Subject: Braidwood Station Units 1 & 2
Braidwood Construction Assessment Program
Monthly Meeting Minutes/Monthly Report
Docket No. 50-456 and 50-457

Meeting Summary
BCAP NRC/CECo/ERC Monthly Meeting
January 3, 1985 9:00 a.m.
Mazon EOF

BRAIDWOOD CONSTRUCTION ASSESSMENT PROGRAM

CSR-I-H-003-005-003

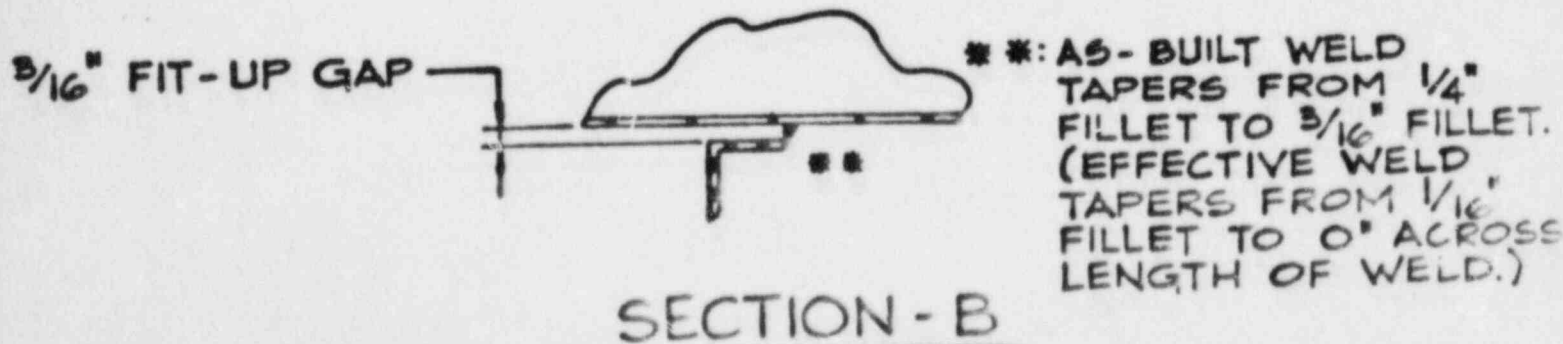
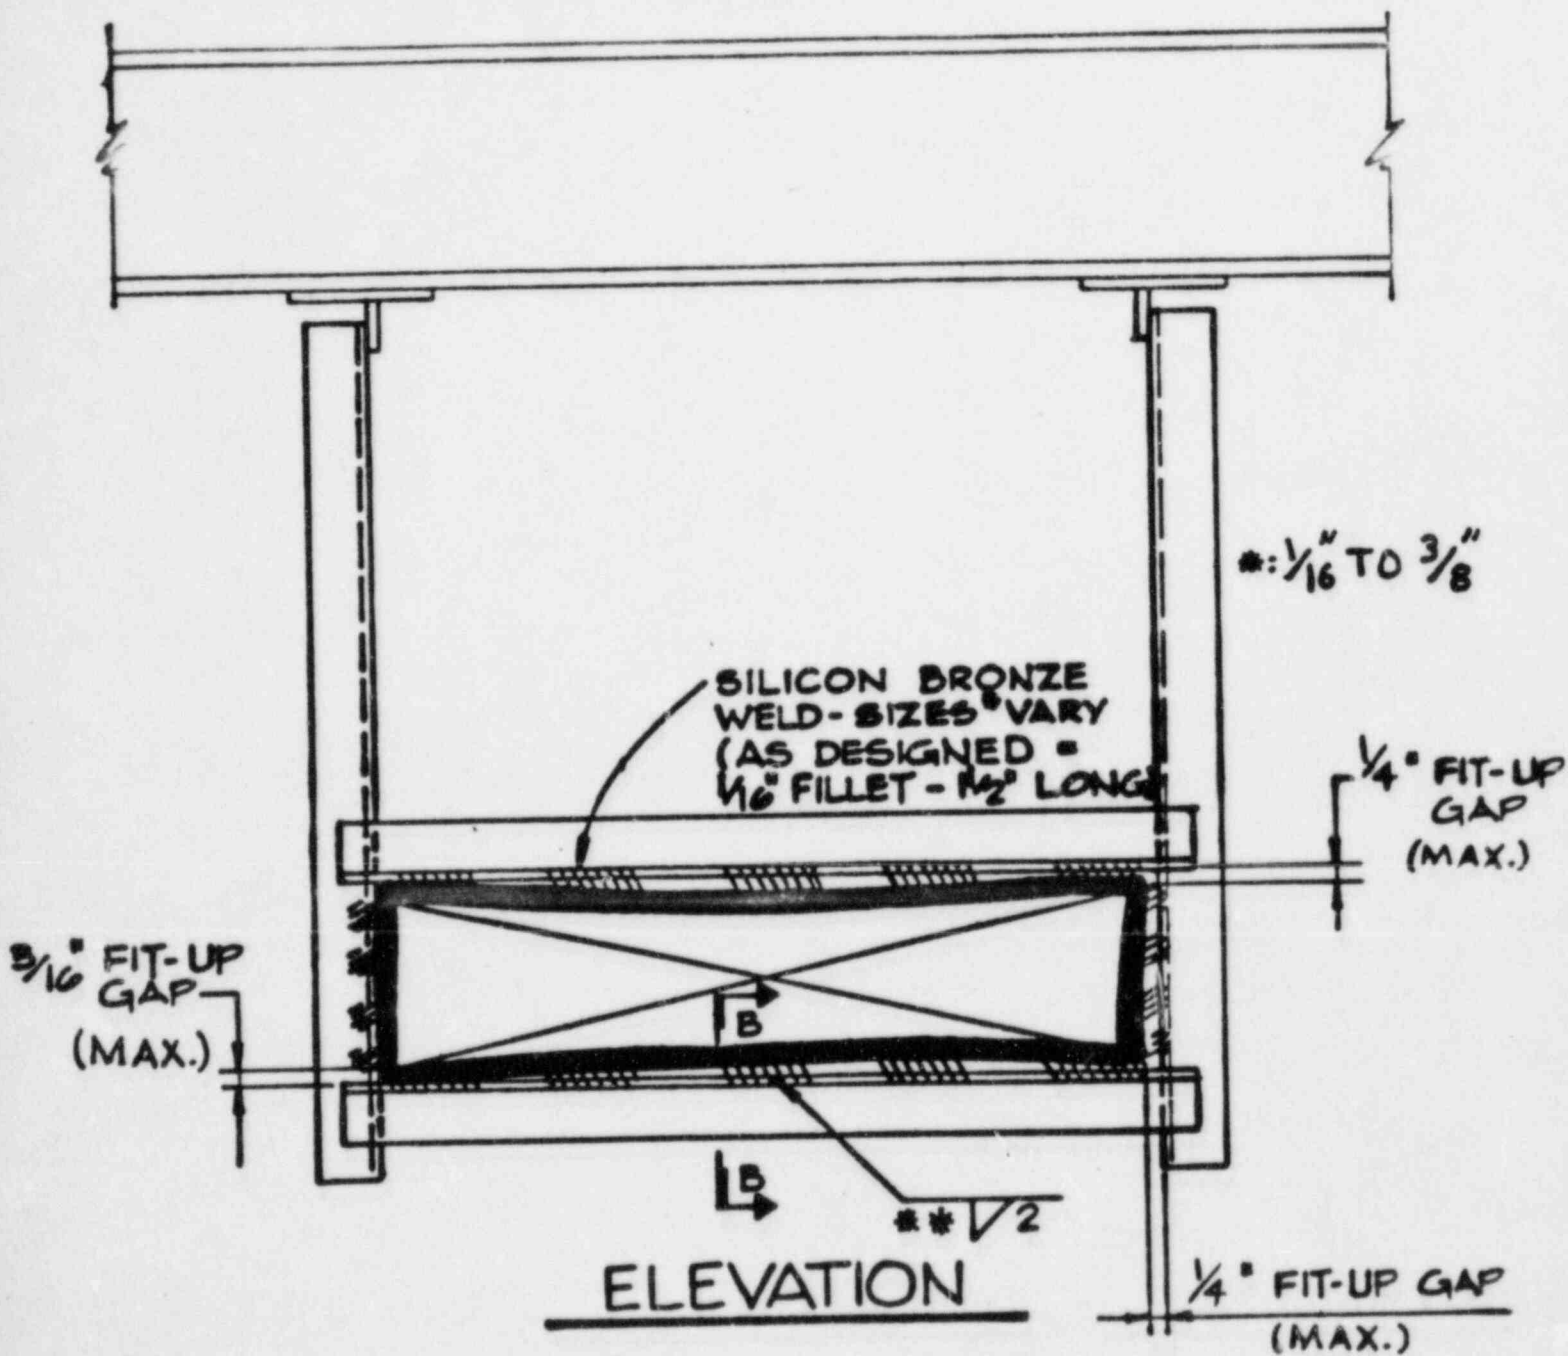
FIT-UP GAP ON HVAC DUCT TO HANGER WELDS
